Product Change Notification

Change Notification #: 119625-00

Change Title: Intel® Server System R2208WFTZSR,
PCN 119625-00, Product Design, Label,
Power Supply (PSU) label update

Label-Before

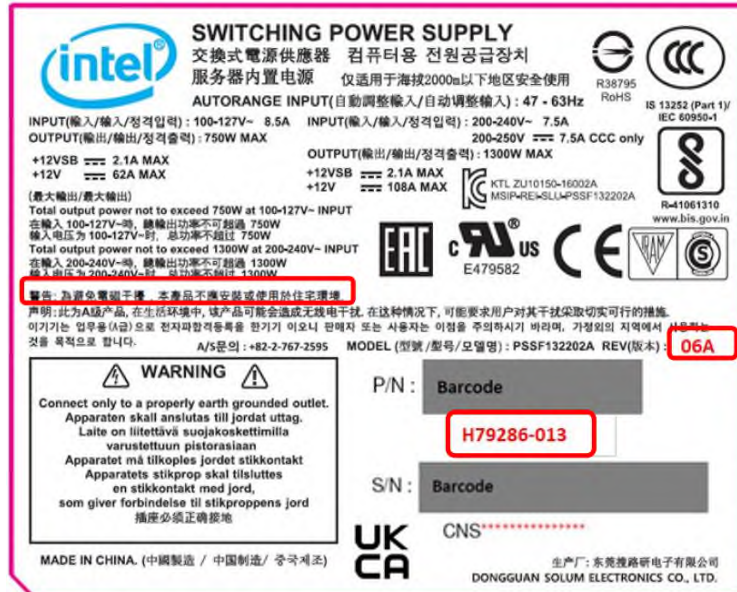
Addition of updated AXX1300TCRPS 1300W Power supply to the R2208WFTZSR SKU. The AXX1300TCRPS 1300W Power supply is changing from H79286-012 to H79286-013 due to a label update to incorporate the new Taiwan BSMI standards CNS15936 (CISPR32) and CNS15598-1 (IEC62368-1). The new BSMI standard has updated warning text that goes into effect January 1, 2024. Additional changes include a PSU firmware upgrade from 29.5.128 to 30.5.128 and a revision change from 05A to 06A. There is no impact to functionality.
